RotorSport UK Ltd

Service Bulletin

SB No.: 054 Iss2	CCAR No.: None	Classification:
Aircraft type & model (applicability) MT-03 MTOsport	Aircraft serial Nos. effected RSUK/MT-03/all RSUK/MTOS/all before 045	OPTIONAL or RECOMMENDED or MANDATORY

Problem description & cause of problem if known
A recent review of the electrical system of MT-series aircraft has identified an opportunity to improve the match of fuse ratings to the circuits protected. Embodiment of this service bulletin will also make the fuse values common across all aircraft.

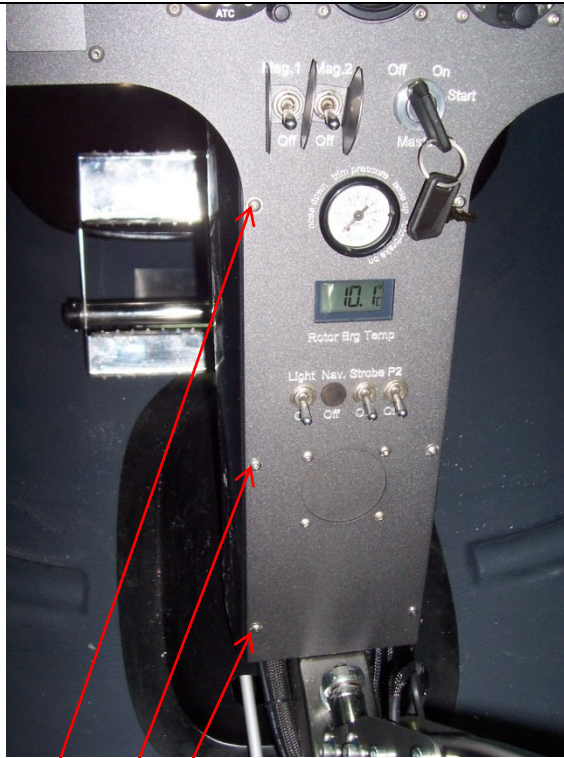
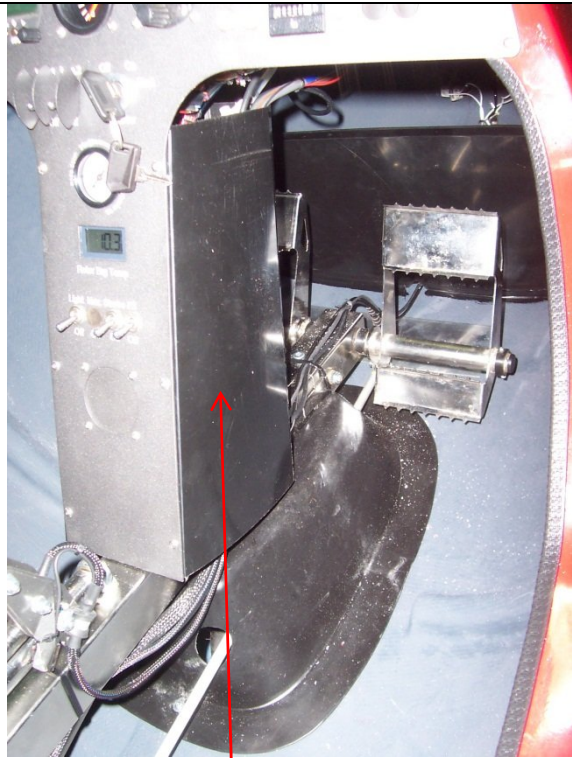
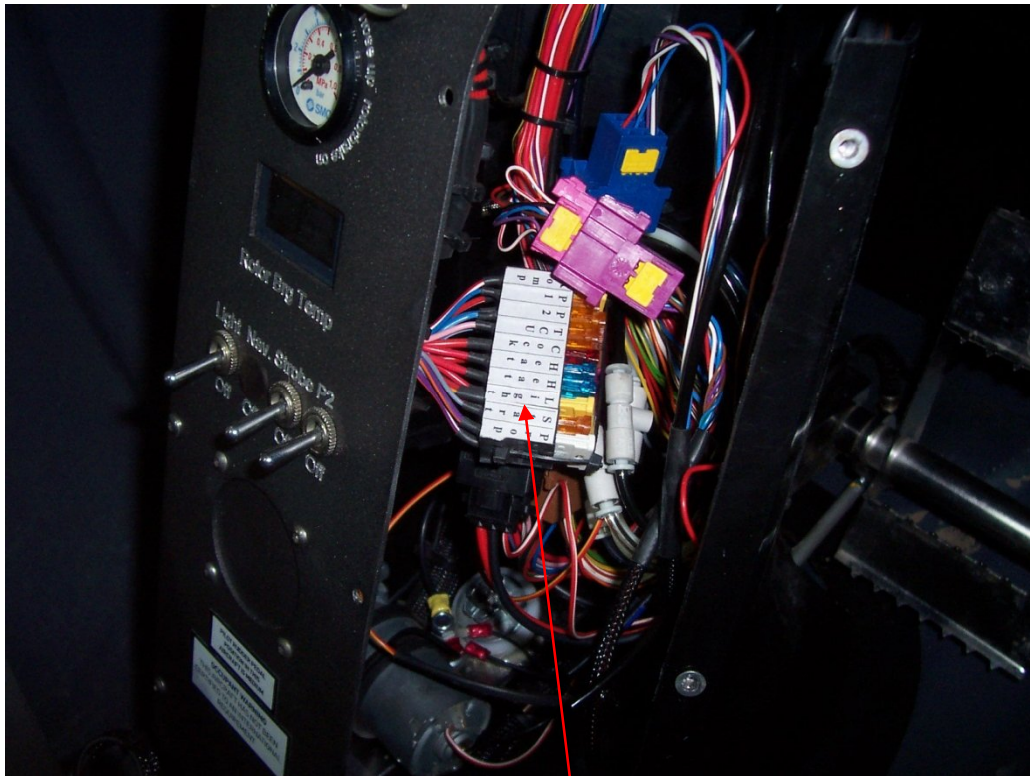
3. The fuses are fitted to a single fuse-block located inside the black plastic enclosure attached to the lower section of the instrument panel. Access may be gained by removal of three M4 dome-head screws (either the left or right-hand set) then carefully opening the enclosure side. The wiring harness may then be positioned to allow access to the fuse block.

4. The fuses have a conventional push-fit into the fuse block (as automotive practice), but have a safety-tie around the whole set. This may be carefully relocated to one side to allow fuse replacement. Alternatively, if found damaged it may be replaced (it is a standard 2.4mm cable-tie)

5. Change the fuses as required to match the appropriate table below. Reinstall the safety-tie then position the wiring harness inside the enclosure which may then be refitted to the instrument panel. There is no loctite used on the three retaining screws.
